RIDEM SUBMISSION

EXETER OFFICE TRADE CENTER

RI DEPARTMENT OF ENVIRONMENTAL MANAGEMENT
 OFFICE OF WATER RESOURCES
 FRESHWATER WETLANDS PROGRAM
 APPROVED WITH CONDITIONS AS
 SPECIFIED IN THE LETTER OF APPROVAL
 DATED: OCT 11 2023 FILE # 22-0334
 NO CHANGES ALLOWED WITHOUT PRIOR APPROVAL
 APPROVED PLANS MUST BE AT CONSTRUCTION SITE
Randy L. Freeman

SITE LAYOUT PLAN
EXETER OFFICE TRADE CENTER
EXETER, RHODE ISLAND
C & H PROPERTIES, LLC
400 SOUTH COUNTY TRAIL, EXETER, RHODE ISLAND 02822
TEL. 401-636-0462

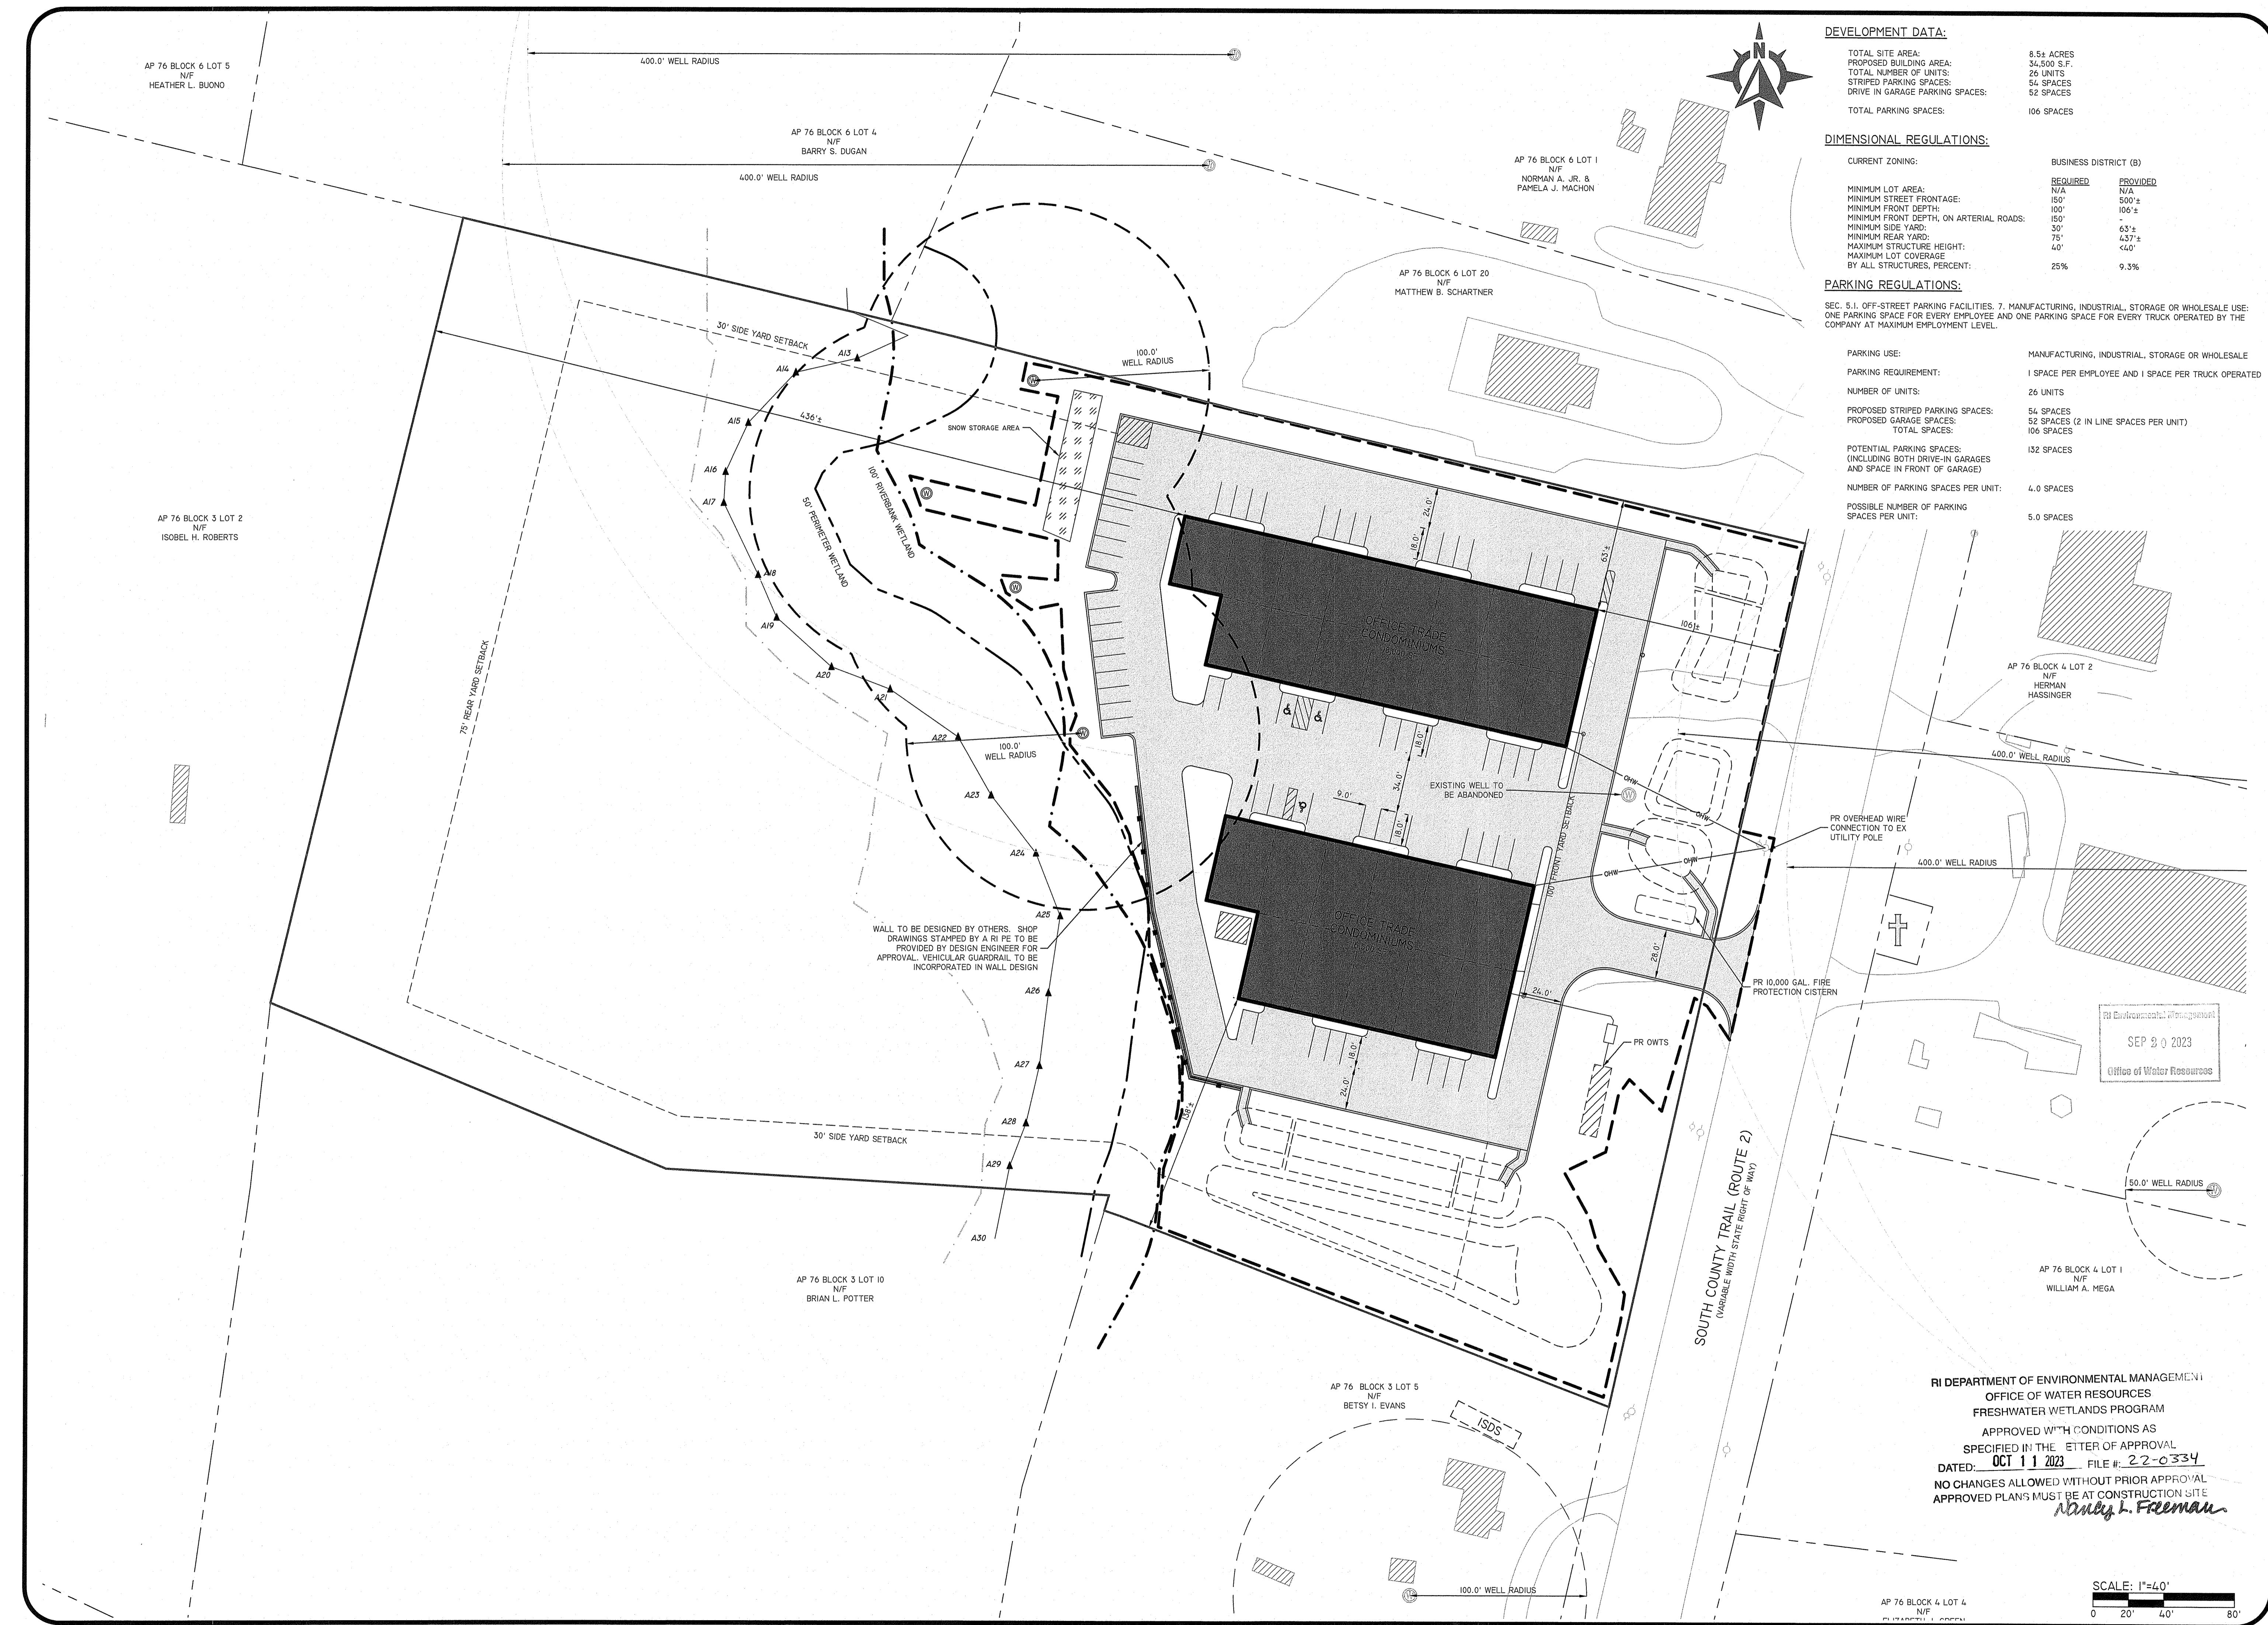
Revised Limit of Disturbance per RIDEM to provide 5-foot for retaining wall installation. See Condition No. 18
